**TOWN OF PORTOLA VALLEY
ARCHITECTURAL AND SITE CONTROL COMMISSION (ASCC)
Monday, November 24, 2014
7:30 PM – Regular ASCC Meeting
Historic Schoolhouse
765 Portola Road, Portola Valley, CA 94028**

MEMORANDUM

RE: Architectural Review and Site Development Permit for a New Residence, Second Unit, Pool House, and Swimming Pool, File # 44-2014, APN: 079-220-010, 40 Antonio Court, Melton Residence

C-2.0
 03 OF 11 SHEETS

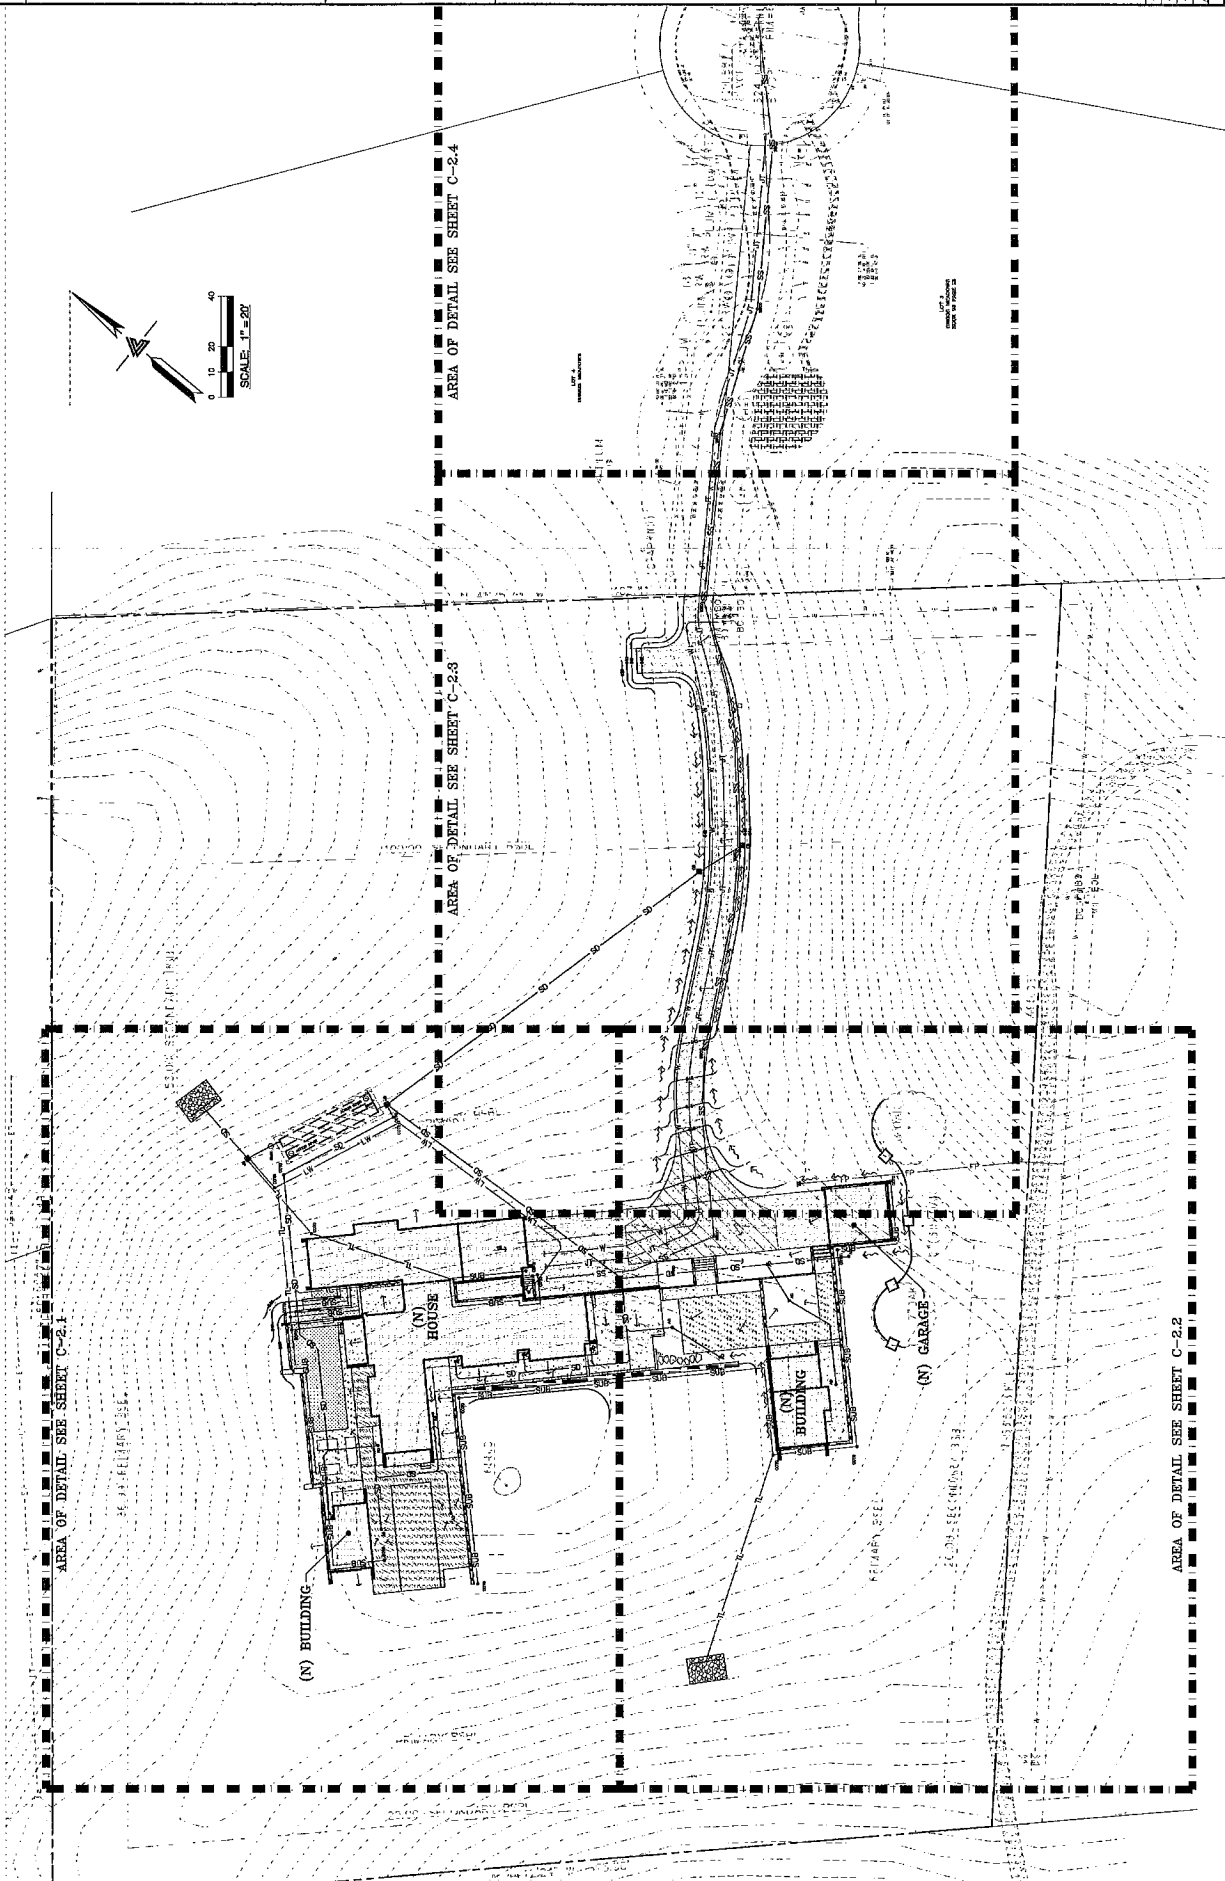
Conservation Committee. The committee's preliminary comments were generally positive. However, it noted the extensive impervious driveway and questioned the need for a symbolic gate in the front yard setback. (Attachment 7)

The Commission has questioned the need for a symbolic gate. The applicant has replaced the vehicular gate and wood rail fences with a pair of 4' tall salvaged wood entry posts. The down shielded path lights originally proposed in front of the gate have also been removed. It should be noted that the driveway backup/turnaround area at the entrance to the property shown on Sheet A1.1 encroaches into a 20' public utility easement and does not match the design shown on landscape site plan (Sheet L1.0) and civil engineering site plan (Sheet C2.0). Condition of approval #2 requires the site plan be corrected.
